SERVICE BULLETIN

No. 8

SEC. VIII
SERVICE BULLETIN
ISSUED MARCH, 1962
REVISED MAY, 1962

SUBJECT: FUEL TANK CAP

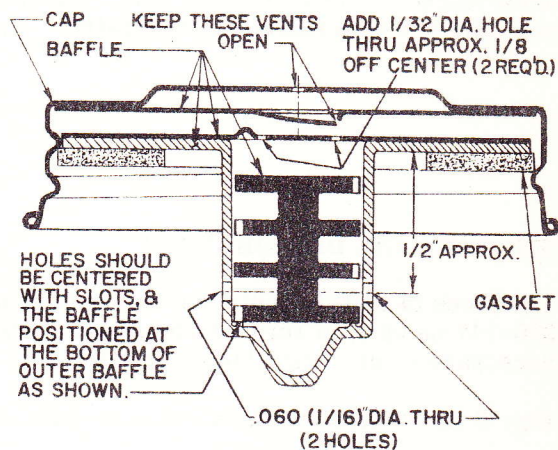
If a problem in high speed or idle setting is noted; loosen fuel cap to see if this affects the setting.

If Carburetor adjustment is affected by loosening cap, remove cap and disassemble. Drill two holes approximately $1/16"$ and not over $3/32"$ as illustrated. This secures adequate atmospheric venting.

An additional hole ($1/32"$) should be added to center baffle. Clean parts prior to reassembly.

SUBJECT: BLOCK OIL SEAL INSTALLATION 4 CYCLE ALUMALLOY

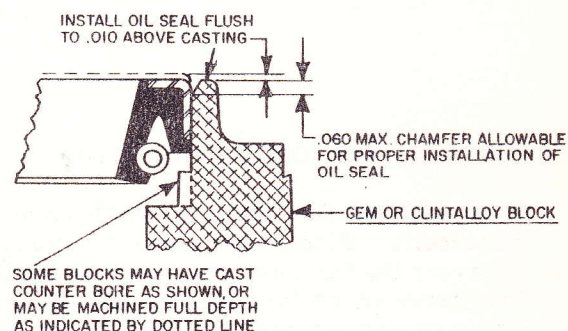
Figure illustrates the proper depth of installation for the Oil Seal in either Vertical or Horizontal 4 Cycle Alumalloy (400, 401, 402, 403, 404, 405, 408 & 409) also 4 Cycle Clintalloy models (406, 407 & 424); also Horizontal & Vertical Gem & Clintalloy models (100, 2100, 3000, 3100 & 4100).

In some cases the Oil Seal can be installed too far into the counterbore causing the lip of the Seal to touch the edge of the Block Bearing. This can result in Seal leakage due to the contact. Installation of Oil Seals is covered also in Sec. VI, Div. C, Pages 8, 12, 13 & 14.

SUBJECT: INSTALLATION OF BREAKER SEAL, SPRING, PUSH ROD & SEAL ON A1600, 1800, B2500, 2790, 414, 418, 420 & 422 SERIES

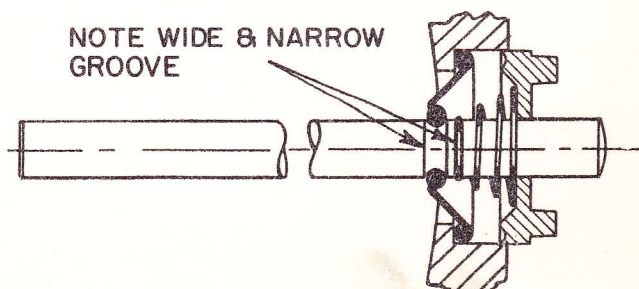
The proper assembly of the parts illustrated will prevent Oil from leaking into the Breaker Point area. Note the position of the Seal & Spring. Replace worn or damaged parts prior to reassembly.

SUBJECT: FRAYING OF HI TENSION LEAD
(Models-A1600, 1800, B2500 & 2790)

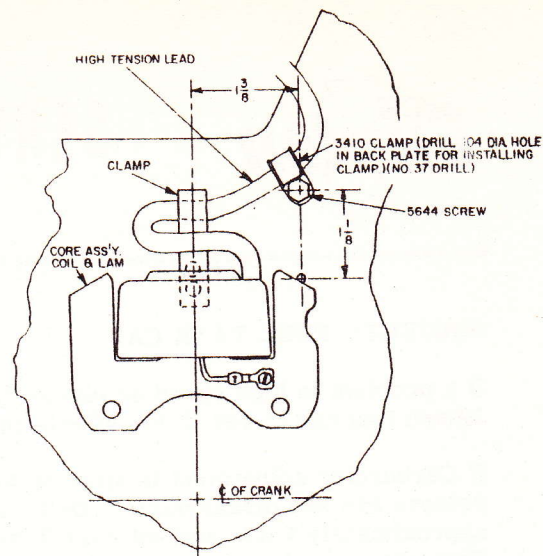
Figure illustrates the addition of and positioning of a 3410 Clamp and 5644 Screw. Should fraying of hi-tension lead be caused by contact with Flywheel, the fastening of Lead as illustrated, will remove the reoccurrence of the problem. If leakage has been experienced on the hi-tension lead, replace with a new lead and then fasten as illustrated.

SUBJECT: OIL DISTRIBUTORS

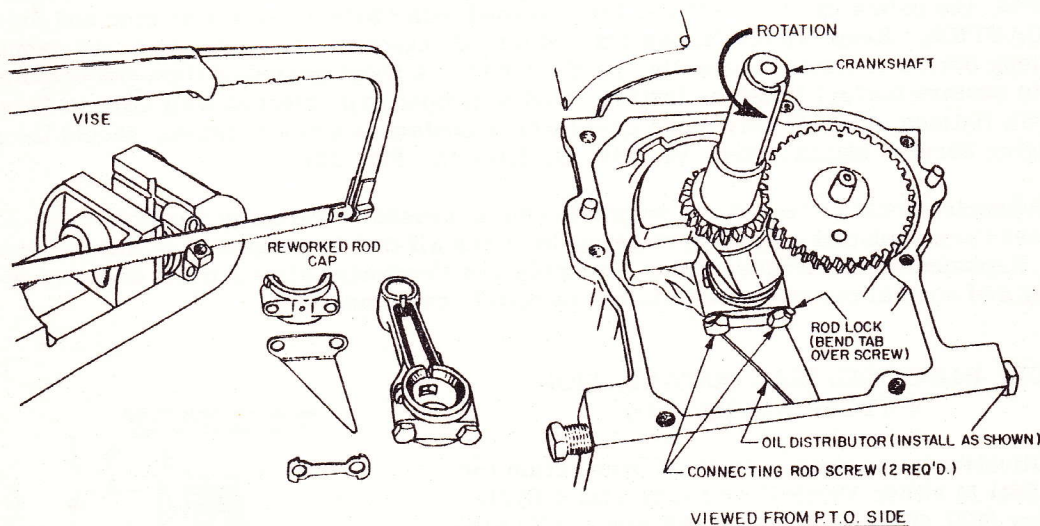
The Stock of 31017-1 Oil Distributor is exhausted at the factory and this will require that Oil Distributor 220-147 be used in service when field stock used up. Fig. 1 illustrates Rods with oil scoop & removal is necessary to use Distributor 220-147.

Fig. 2 illustrates Oil Distributor in place and 31018 Rod Lock should be used with 220-147 Oil Distributor.

NOTE: If Rod is held in vise, protect Rod face's from burring or damage also smooth Rod Cap after cup cut-off to secure smooth flat surface for distributor.
